**RE: RIBBON DEVELOPMENT SSD-5397 – CLARIFICATION OF RESPONSE TO SUBMISSIONS**

Kass-Hermes have been engaged by Anson City Developments Pty Ltd (Anson), which has a majority interest in the Emporio Building at 339 Sussex St Sydney, to act on their behalf in relation to the above development.

**Figure 1-** Aerial photograph of Cockle Bay illustrating the indicative increase in view area from the Emporio building if the Ribbon Development is not constructed over Harbour St.

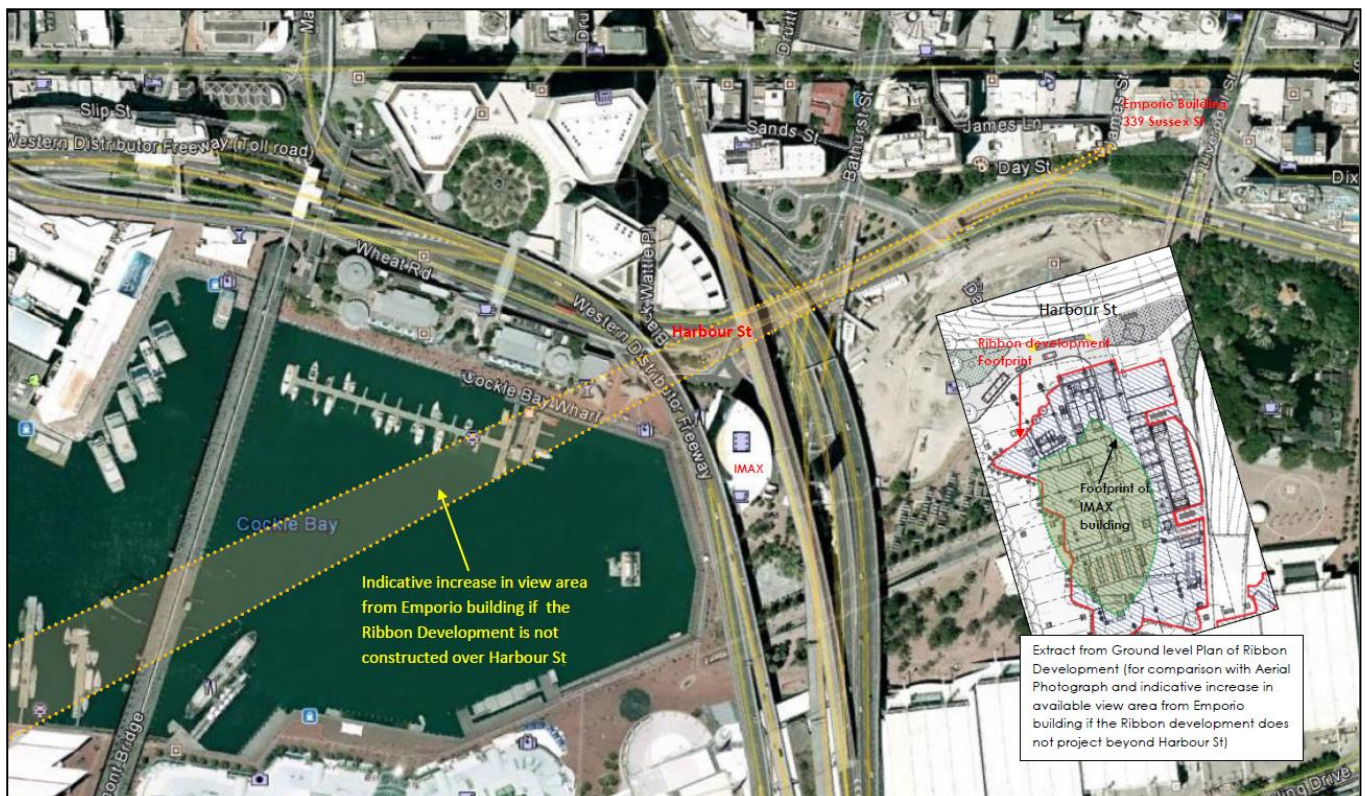
The distance of the most affected apartments from the water's edge is approximately 320m. The **view area affected the projection of Ribbon development over Harbour St** lies directly along the axis of Harbour St (**Figure 1**) and **is not affected by any developable land**. The impact of the loss of view from the most affected apartments is significant.

Notwithstanding that there may be no expectation of view retention in general within the City, **there is a strong expectation that the existing views along Harbour Street to Cockle Bay would not be affected as there are no developable sites between the Emporio Building at its north-western corner and Cockle Bay along the axis of Harbour St (Figure1).**

**It is therefore submitted that it is absolutely reasonable to expect that the uninterrupted views across a Harbour St to Cockle Bay, as illustrated in Figure 1, would be retained.**

**Figure 2** – Extract from GMU Report: View Impact from Level 20 of Emporio Building

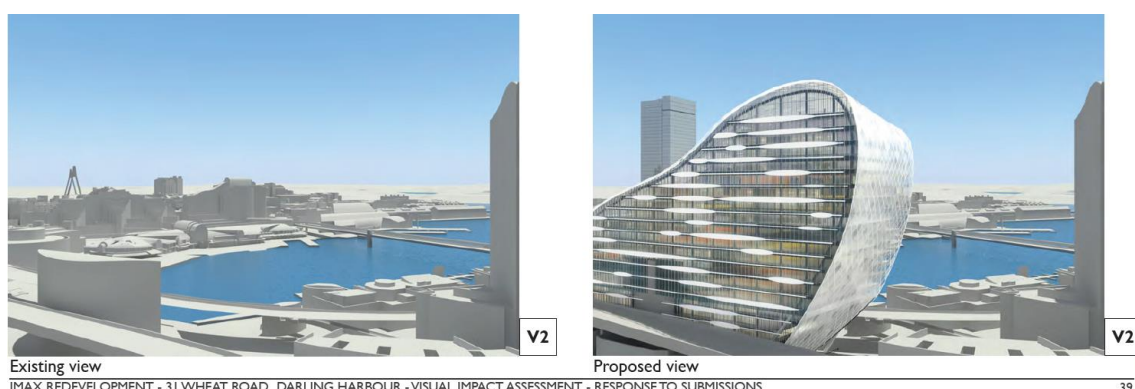
**Comment:** The applicant's View Impact Assessment identifies the view from Level 20 of the Emporio Building as follows:

The applicant's View Impact Assessment on the views from the upper level (Level 20) of the Emporio Building states:

*"Although the impact is considered to be severe, it is considered to be acceptable as the precinct is undergoing a change in the scale of the built form and there should not be expectation of the retention of views for properties immediately behind development sites facing Darling Harbour".*

**Figure 3** – Extract from GMU View Assessment Report - View Impact from Level 13 of Emporio Building

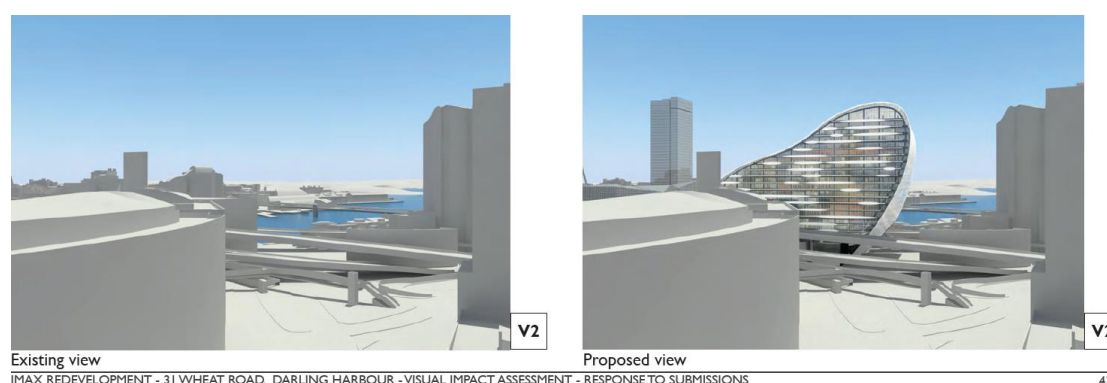
Views from Level 13 are assessed by the applicant's consultant as follows:

**Figure 4 - Option 3:** Building with large ground floor base and single tower

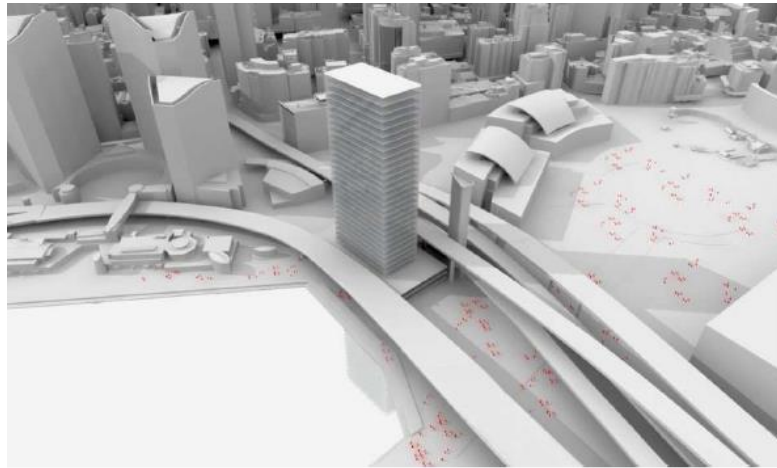
It is significant that in reviewing design options, the EIS for the proposal states that Option 3 (building a tall single tower on a large footprint) would create issues of pedestrian connections and movements to public domain areas as well as significant overshadowing to the public domain areas.

**Figure 5 - Option 5:** Building with wider built form cantilevering over expressways

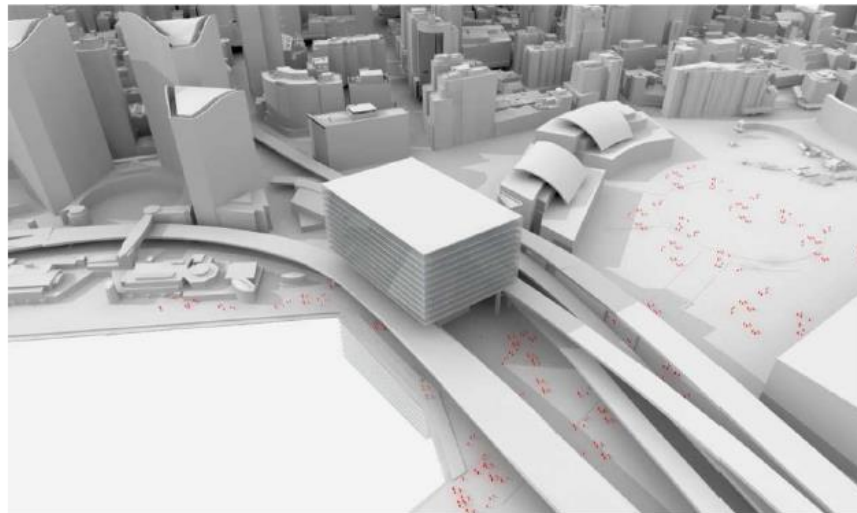
Option 5 (building partly over the expressway) was perceived as top-heavy as well as creating significant overshadowing over the public domain. Option 4 (Two thin Towers) had similar overshadowing issues.

**Figure 6 - Option 6:** Building with a thinner built form matching the height of surrounding buildings

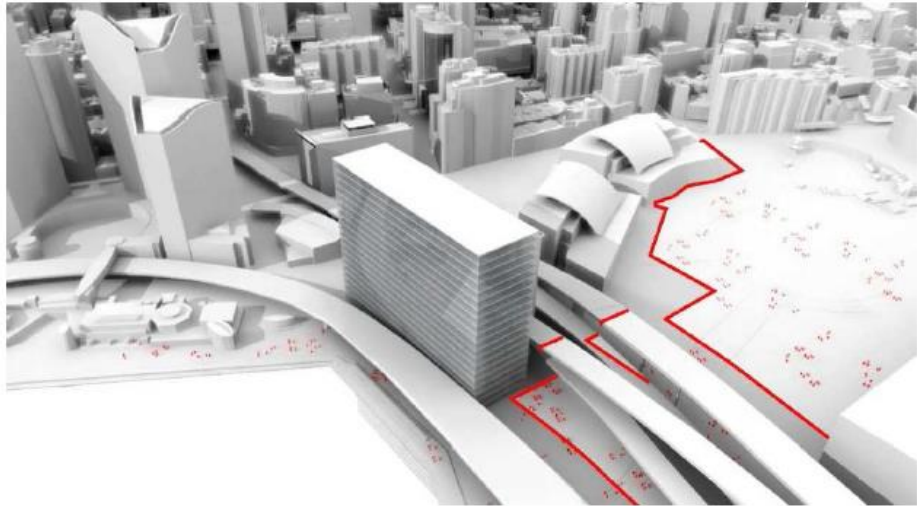
Option 6 (a thinner mass with height comparable to neighbouring buildings) was perceived as more pleasing visual outcome but resulted in overshadowing of the children's playground; even though children's playgrounds are generally now provided with shading structures as preventative measure against skin cancer.

**Figure 7 - Option 7:** Building over Harbour St

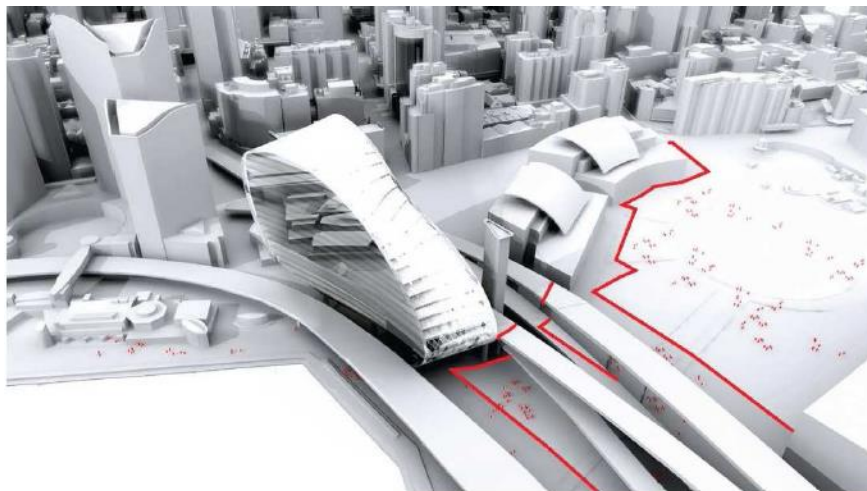
As a consequence, Option 7 (the subject development) was selected as the preferred design.

**It is submitted that notwithstanding that any number of the above design options could have been made to work, Option 7 was selected.**

**It is considered that a more skilful design, with an organic style that proved to be so influential in Option 7, could have provided the applicant with the same development potential and amenity and reduce the impact on the views of nearby residents within the City of Sydney.**
